MILITARY SPECIFICATION

MICROCIRCUITS, DIGITAL, TTL, EXCLUSIVE-OR
GATES MONOLITHIC SILICON

This amendment forms a part of Military Specification MIL-M-38510/7B, dated 21 June 1975, and is approved for use by all Departments and Agencies of the Department of Defense.

FIGURE 3. Schematic circuits.

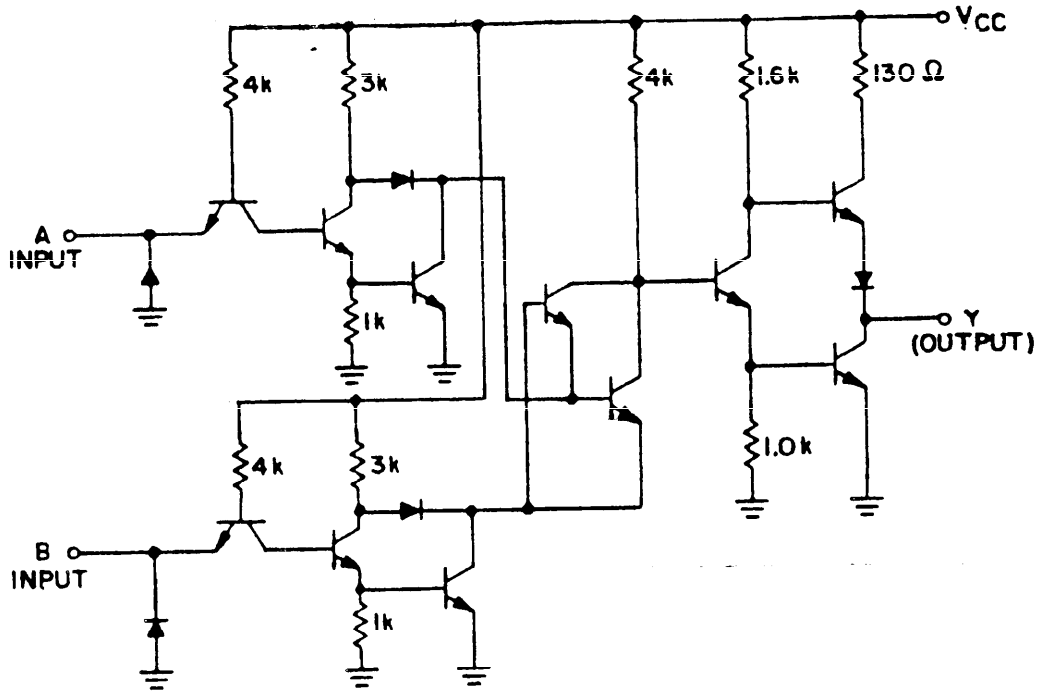
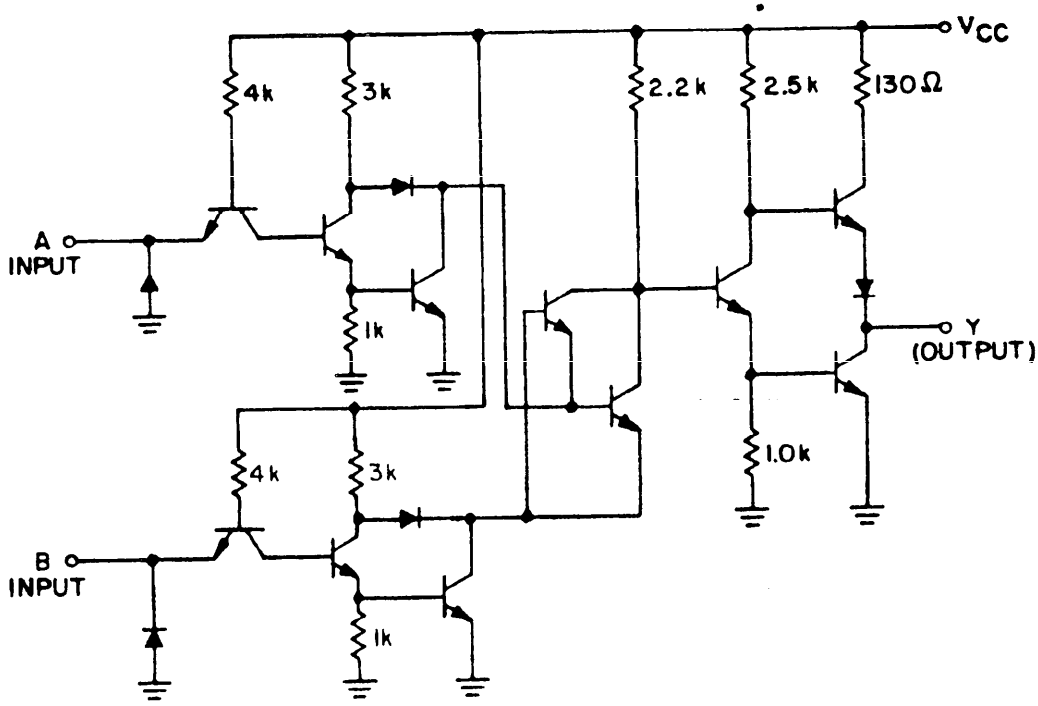
FIGURE 3, schematic circuits: Delete and substitute new circuits as printed on pages 3 and 4 of this amendment.

CIRCUIT C

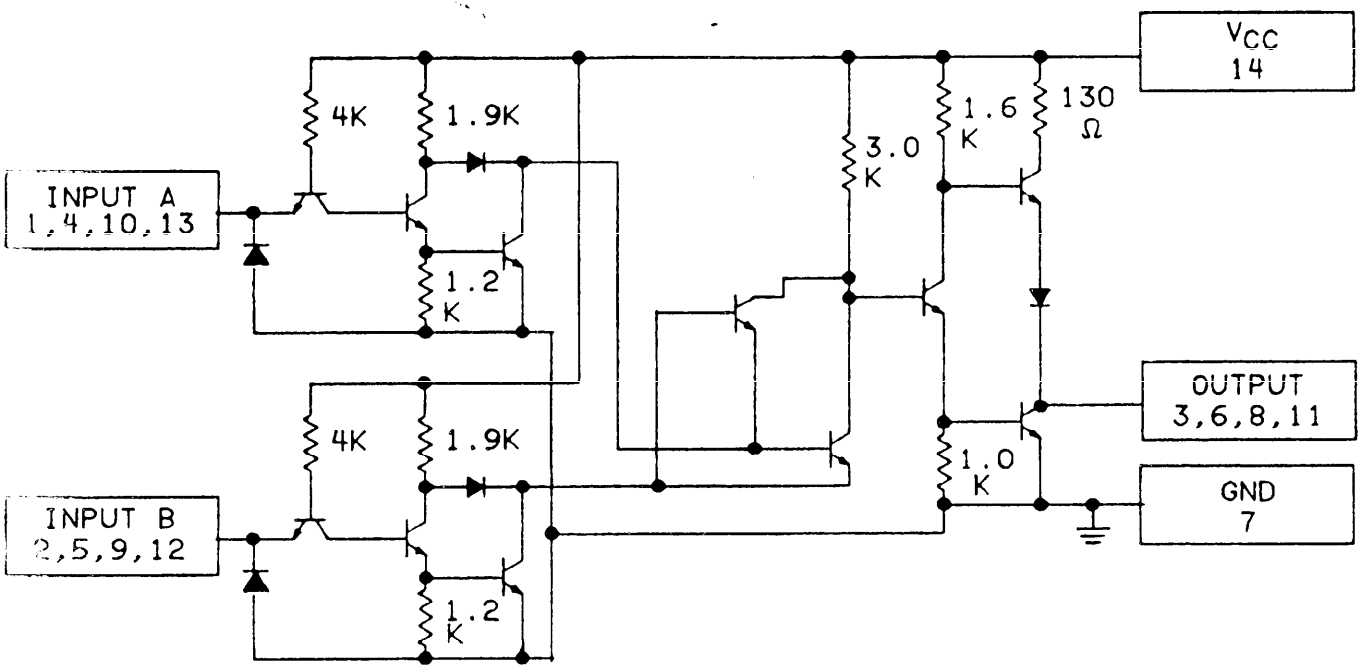
* FIGURE 3, schematic circuits: Delete and substitute new circuit C as printed on page 4 of this amendment.
